Amendment Notice 3

Licence Number L8308/2008/2

Premises Sino Iron Project Mine Site
Mining Tenements M08/123, M08/124, M08/125,
M08/264, M08/265, M08/266, G08/54 and L08/126
MARDIE WA 6714

Date of Amendment 11/08/2017

The tailings deposition models are shown in Figures 1 – 3 below. The discharge spigots are shown by the arrows.

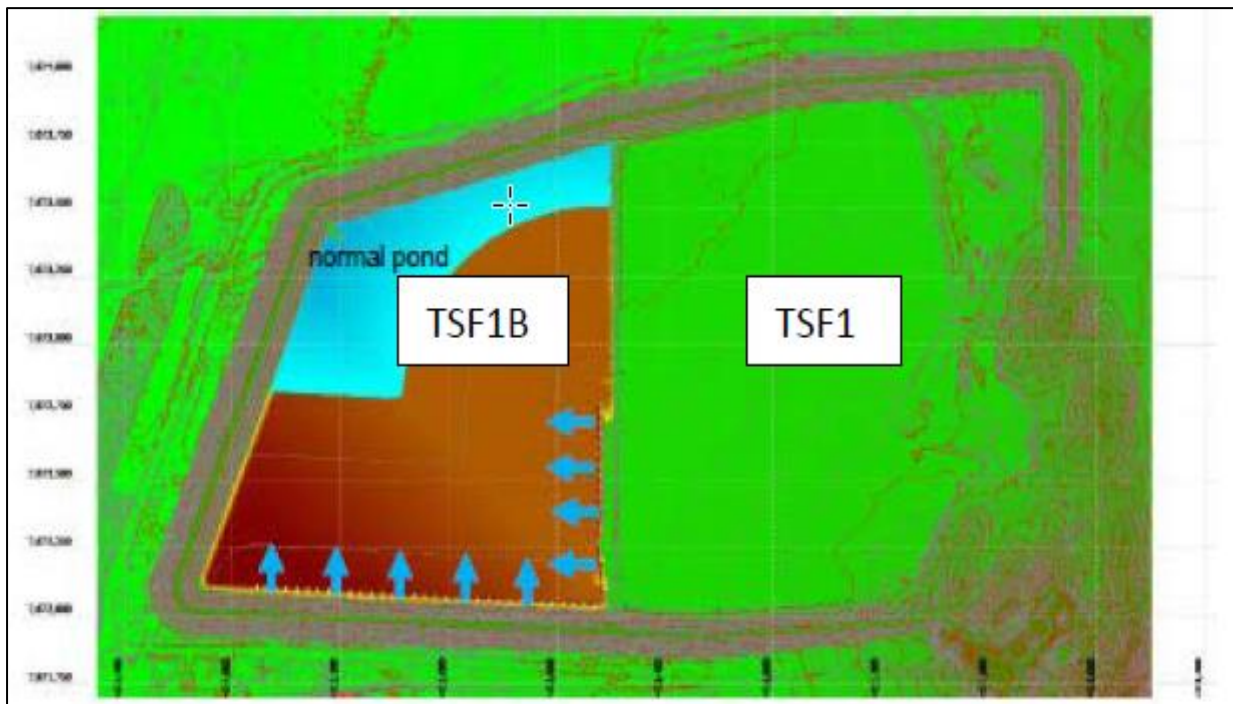
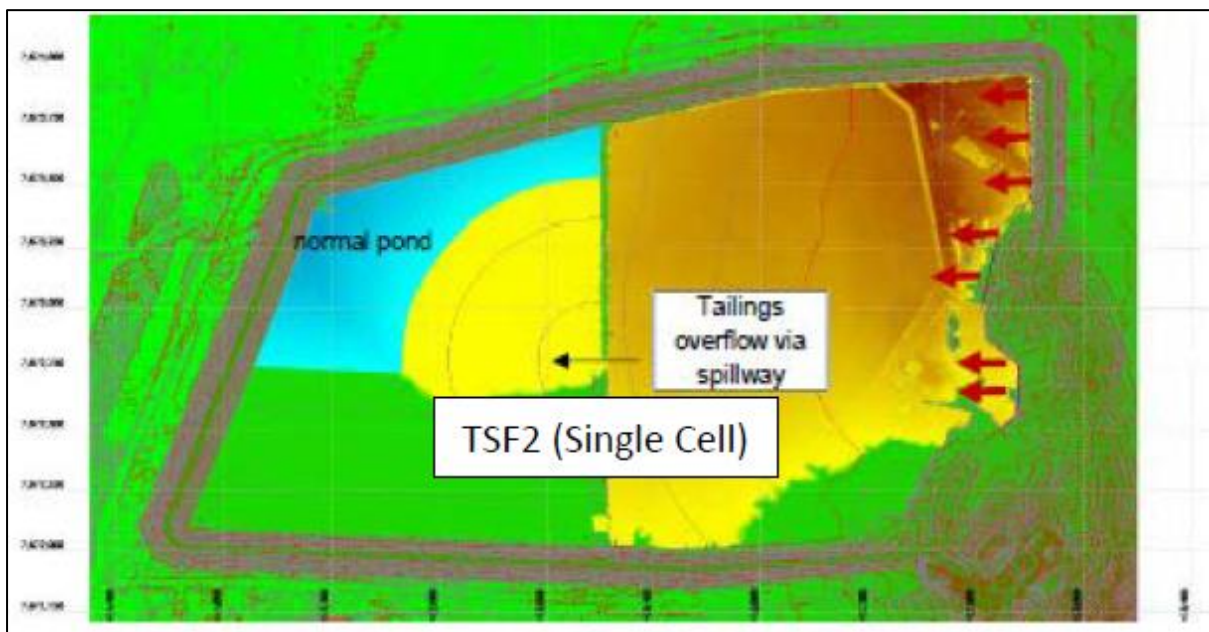
- Construction of TSF Stage 2 and tailings deposition will occur concurrently with downstream embankment construction;
- The TSF Stage 1 northern and eastern embankments will be raised to a minimum of 39 mRL prior to the end of September 2017;

- Discharge spigots will be installed along the TSF Stage 1 eastern embankment;
- A spillway will be constructed along the embankment separating TSF Stage 1 and TSF Stage 1B that allows for controlled breaching of TSF Stage 1 into TSF Stage 1B. From this point in time, the TSF will then be operated as a single cell and referred to as TSF Stage 2; and

- The TSF Stage 2 southern wall will be a minimum of 49 mRL by April 2018 with discharge spigots installed along the southern and eastern embankments. Deposition will be controlled so the tailings head at the eastern embankment is approximately 2 m higher than at the southern embankment to maintain the perimeter decant at the north-west corner.
